PIC16C63 Rev. A Silicon Errata Sheet

The PIC16C63 (Rev. A) parts you have received conform functionally to the Device Data Sheet (DS30234D), except for the anomalies described below.

FIGURE 1: SCK PULSE VARIATION USING TIMER2/2

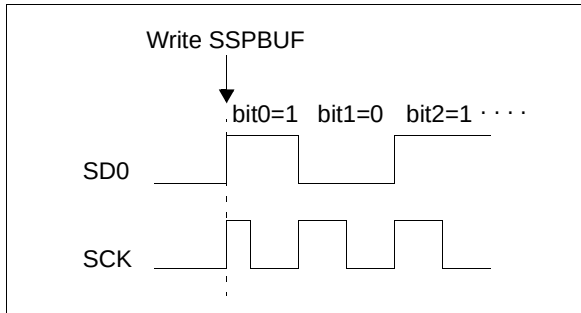
4. Module: SSP (SPI Mode)

When the SPI is using Timer2/2 as the clock source, a shorter than expected SCK pulse may occur on the first bit of the transmitted/received data (Figure 1).

To avoid producing the short pulse, turn off Timer2 and clear the TMR2 register, load the SSPBUF with the data to transmit, and then turn Timer2 back on. Refer to Example 1 for sample code.

FIGURE 1: WRITES TO TIMER1 (EXTERNAL CLOCK/OSCILLATOR MODE)

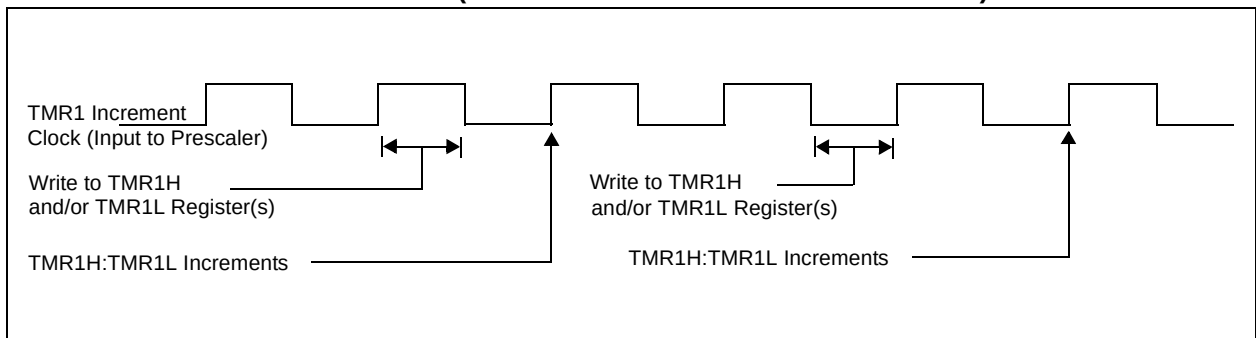
3. Module: Timer1

The operation of Timer1 needs some clarification when the timer registers are written when the TMR1ON bit is set.

The internal clock signal that is the input to the TMR1 prescaler affects the incrementing of Timer1 (TMR1H:TMR1L registers and the Timer1 prescaler). When the Timer1 registers are NOT written, the Timer1 will increment on the rising edge of the TMR1 increment clock.

When the TMR1H and/or TMR1L registers are written while this clock is high, TMR1 will increment on the next rising edge of this clock.

When the TMR1H and/or TMR1L registers are written while this clock is low, TMR1 will not increment on the next rising edge of this clock, but must first have a falling clock and the rising clock for TMR1 to increment.

Figure 1 shows the two cases of writes to the TMR1H and/or TMR1L registers. Due to the V_{IH} and V_{IL} thresholds on the oscillator/clock pins, external Timer1 oscillator components, and external clock frequency, the Timer1 increment clock may not be of a 50% duty cycle.

The TMR1 increment clock is out of phase of the T1OSO/T1CKI pin by a small propagation delay.
